GUIDANCE FOR THE SURVEY AND CONSTRUCTION OF STEEL SHIPS

Fire Protection, Detection and Extinction

AMENDMENT NO.2

Notice No.94 15th October 2010

Fig. R4.2.2-1

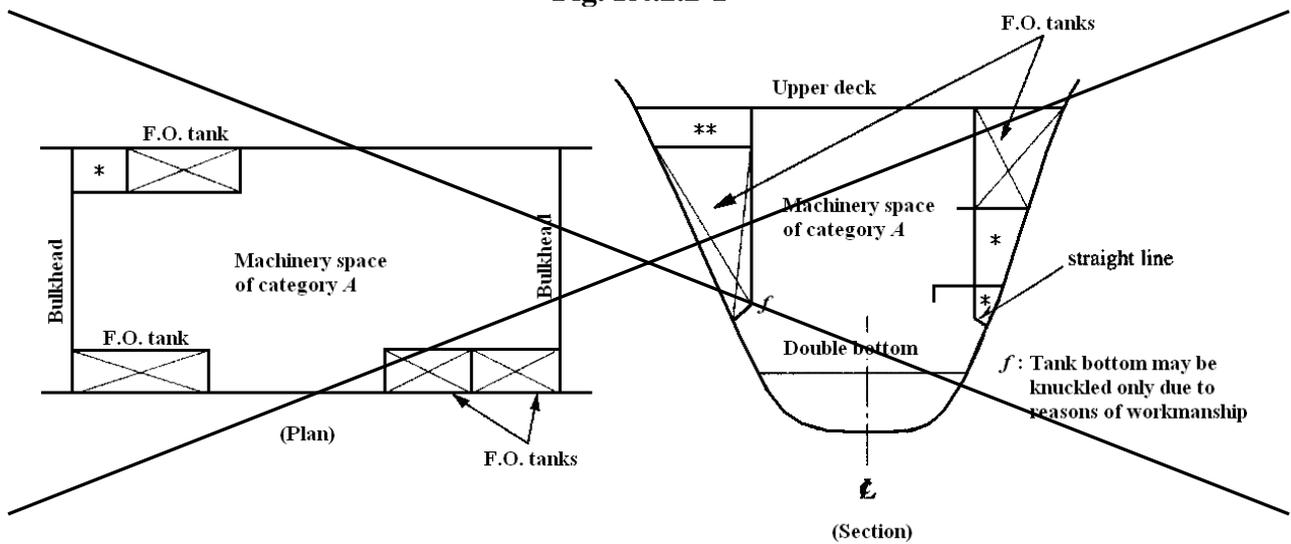
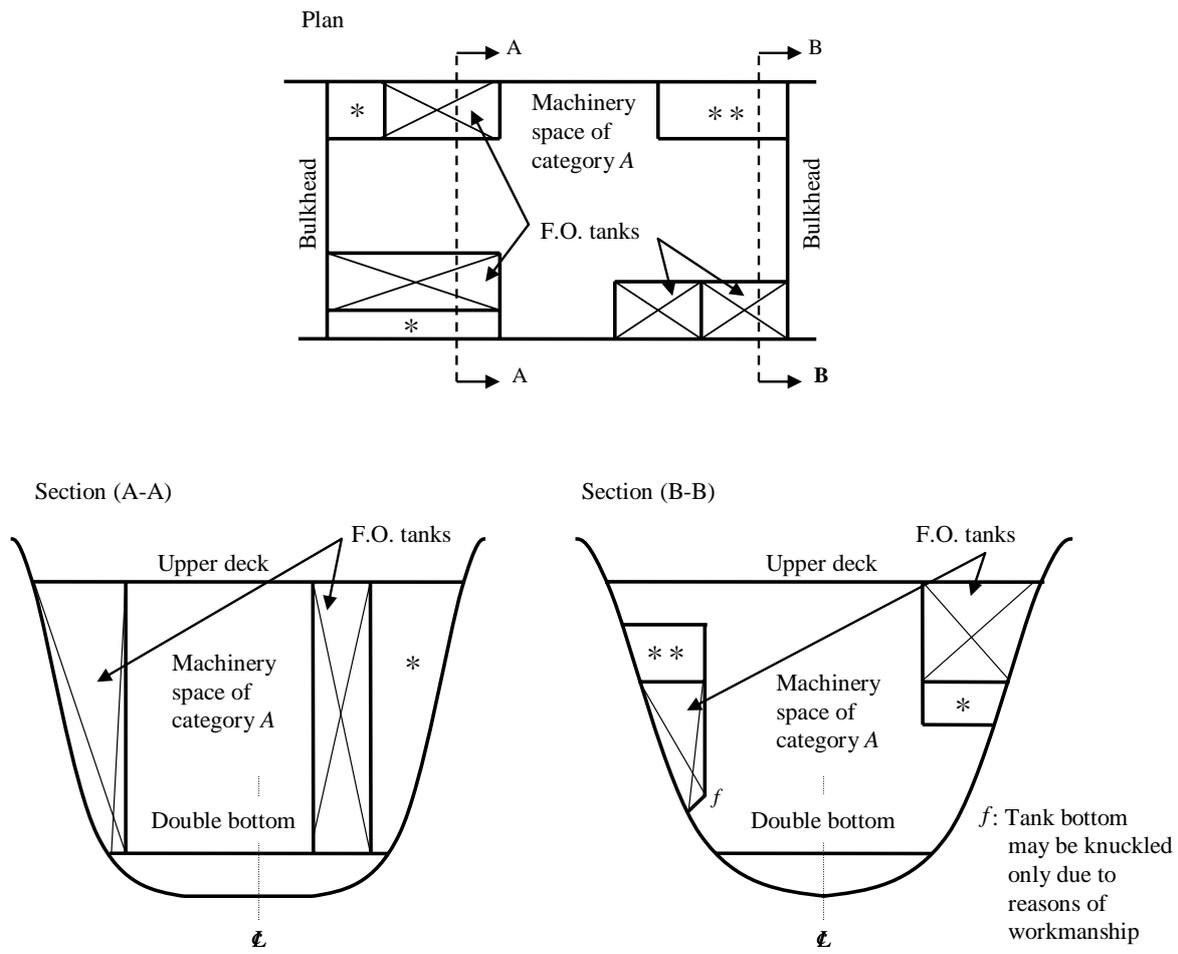
Fig. R4.2.2-1 has been amended as follows.

- * * ~~In case where the top plates of fuel oil tanks are not common with upper deck, cofferdams are to be provided at the upper part of fuel oil tanks or the spaces between upper deck and fuel oil tanks. However, in case where such spaces are intended to be used for void spaces, pipe passages for those other than flammable liquids, fan rooms, air conditioning machinery room, refrigerating machinery room or rooms for hydraulic system and auxiliary machinery which are considered to have little fire risks, provision of the above mentioned cofferdams is not required. In this case, bulkheads exposed to machinery spaces of category A are to be of steel gas tight construction, and doors are to be of self closing type. Void spaces having sufficient depth are to be provided on the tops of fuel oil tanks, and are permitted to have openings. However, in cases where pipe passages for other than flammable liquids, and/or auxiliary machinery rooms having little fire risk, such as fan rooms, conditioning machinery rooms, refrigerating machinery rooms and rooms for hydraulic systems, are provided on the top of fuel oil tanks, it is not necessary to provide the aforementioned void space.~~

- * Cofferdams complying with the following requirements;
 1. to be gas-tight; and
 2. to be provided with sounding devices, air escape pipes and fittings for drainage (drain plug, etc.).

3. cofferdams provided under fuel oil tanks are to have sufficient depth, and equipment that is highly combustible or flammable is not to be arranged under said cofferdams

Fig. R18.2.1-1 ~~Example of~~ **Example of landing area at ship's side**

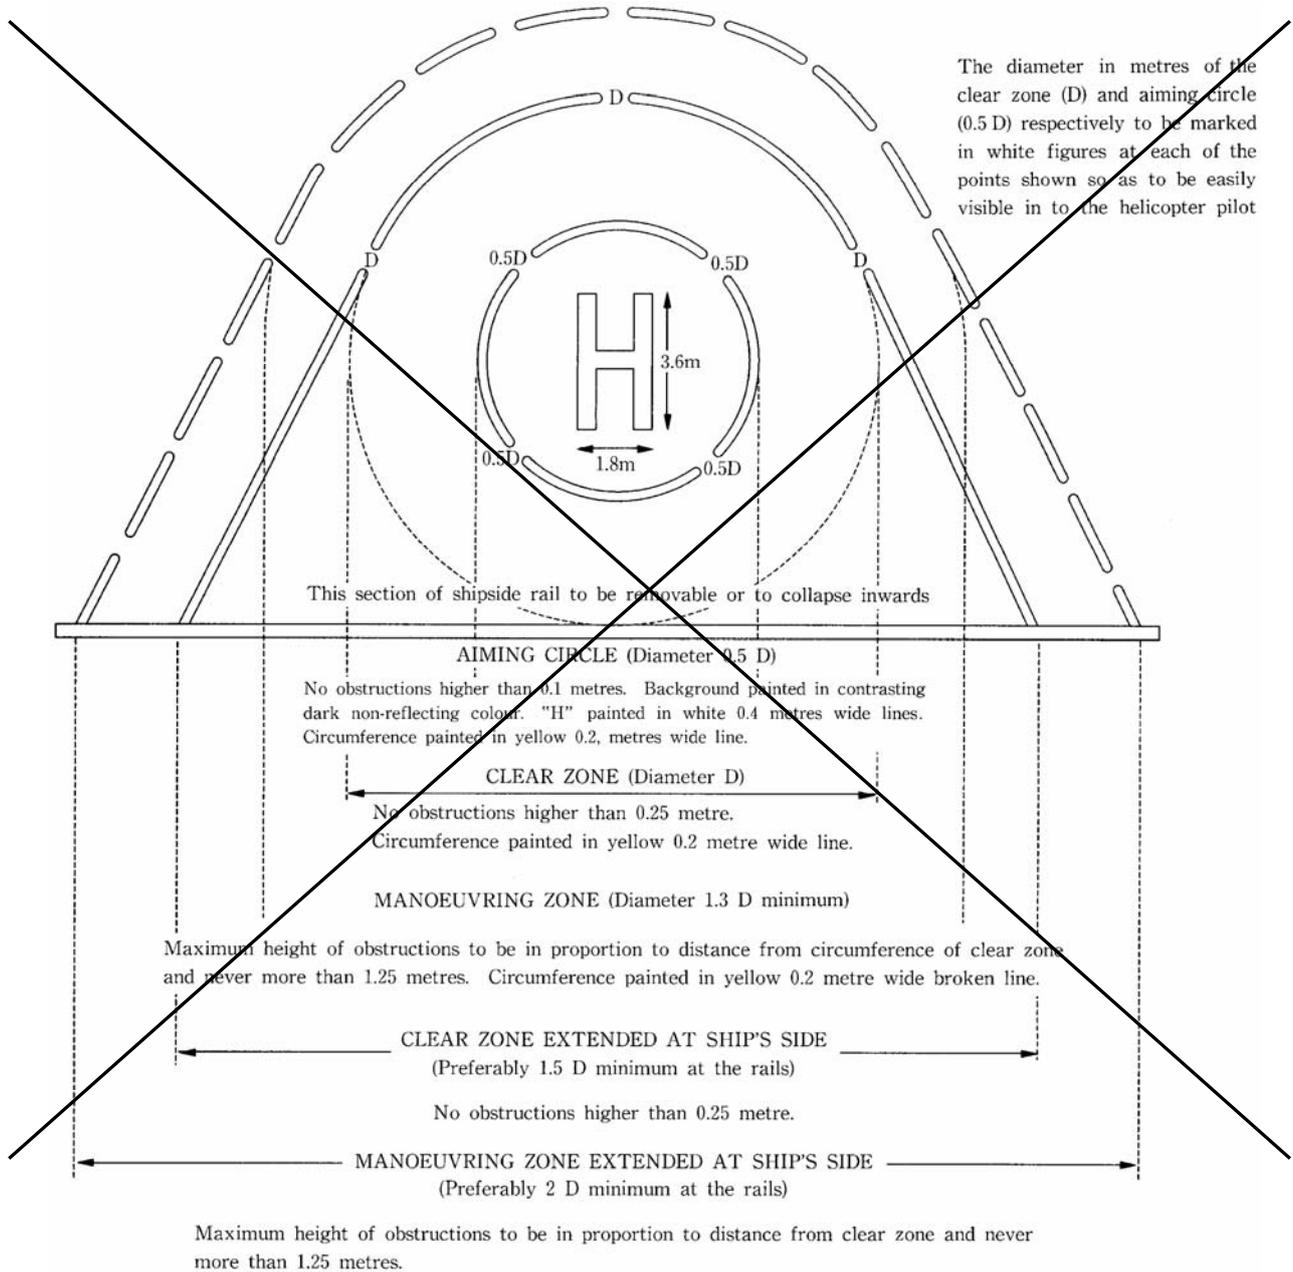
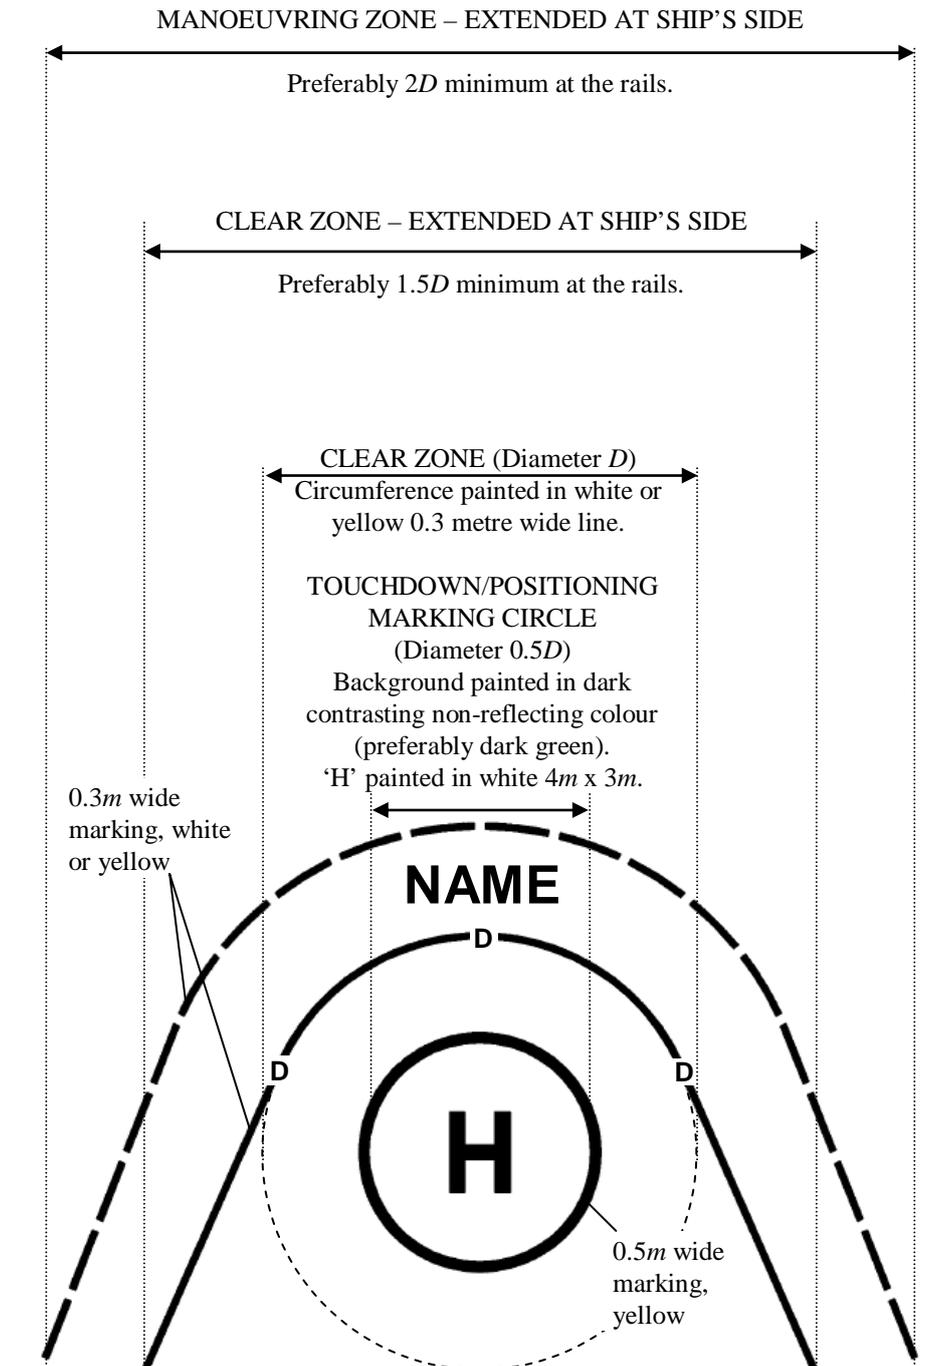
Fig. R18.2.1-1 has been amended as follows.

1. The diameter in metres, rounded down to the nearest whole number, of the clear zone 'D' is to be marked in 0.6m high white figures at each of the points shown, so as to be easily visible to helicopter pilots. The diameter (in metres) of the clear zone is to be equal or greater than the overall length of a visiting helicopter with rotors running.
2. Where practical, the name of the ship is to be painted in a contrasting colour (preferably white) on the inboard side of the manoeuvring zone in (minimum) 1.2m high characters.

Fig. R18.2.1-2 ~~Example of amidships centreline landing area without unobstructed access from ship's side~~

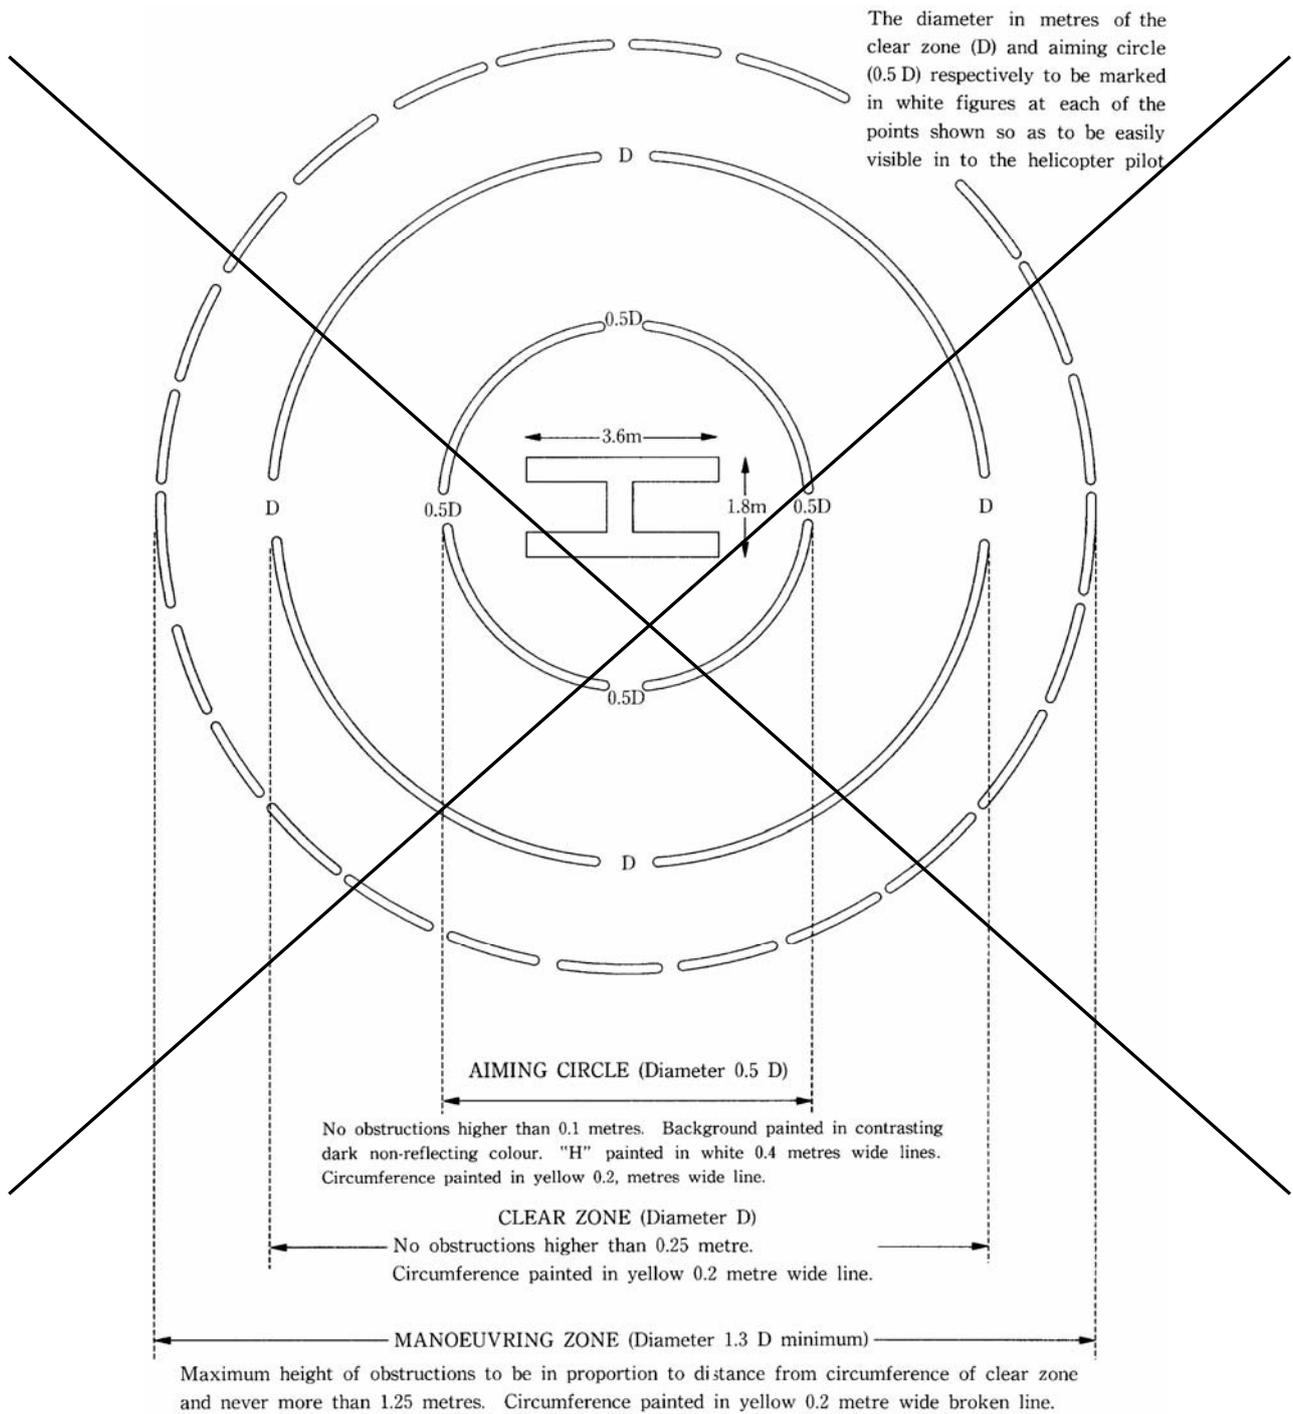
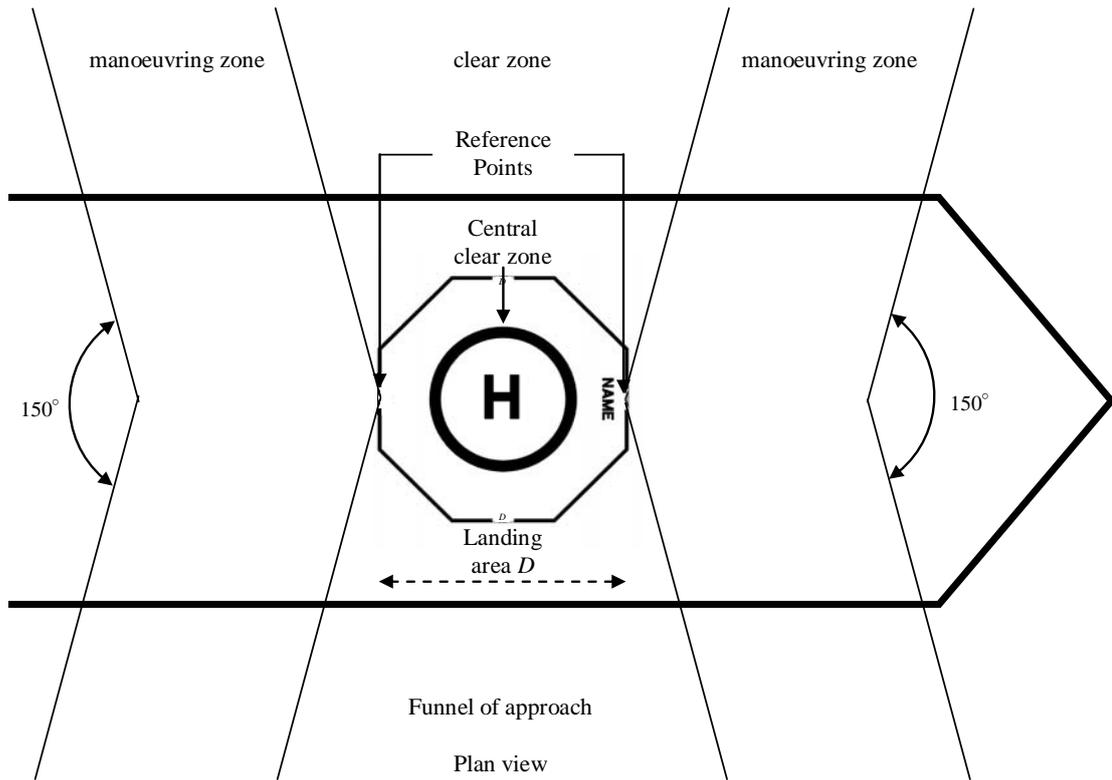
Fig. R18.2.1-2 has been amended as follows.

1. Where it is not possible to accommodate a ship side arrangement, it may be possible to provide a landing area located on or near to the centreline of the ship.
2. Reference points of limited obstacle areas are to be located on the centreline of the circumference of the landing area.

Fig. R18.2.1-3 Example of Markings for amidships centreline landing area

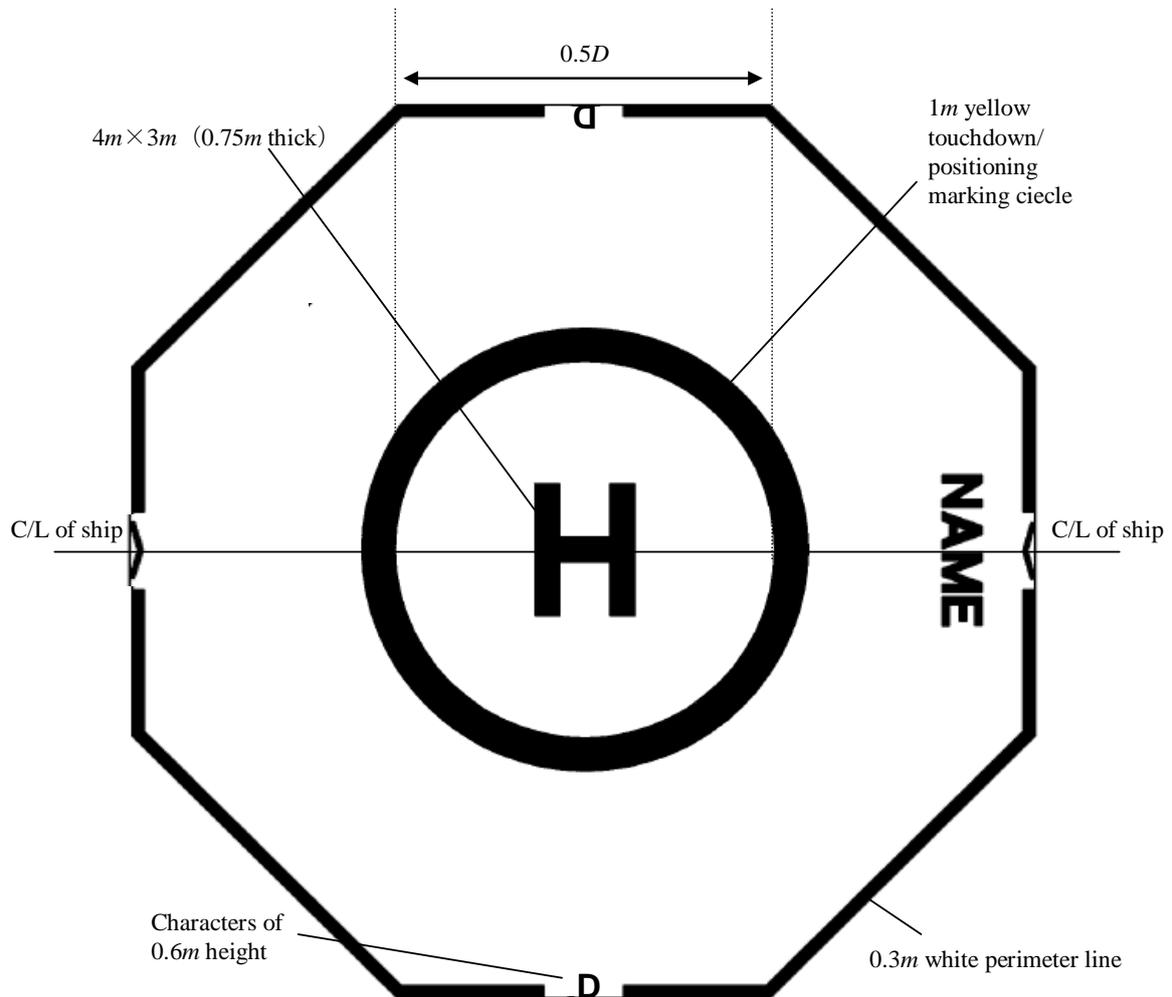
Fig. R18.2.1-3 has been renumbered to Fig. R18.2.1-4 and Fig. R18.2.1-3 has been added as follows.

1. The landing area is to be painted in a colour, preferably dark green, that contrasts clearly with the colour of the ship's deck.
2. The diameter in metres, rounded down to the nearest whole number, of the landing area 'D' is to be marked in 0.6m high white figures at each of the points shown, so as to be easily visible to helicopter pilots. The diameter (in metres) of the landing area is to be equal or greater than the overall length of a visiting helicopter with rotors running.
3. Where practical, the name of the ship is to be painted in a contrasting colour (preferably white) within the landing area, aligned across the centreline. The minimum height of the painted characters is to be 1.2m.
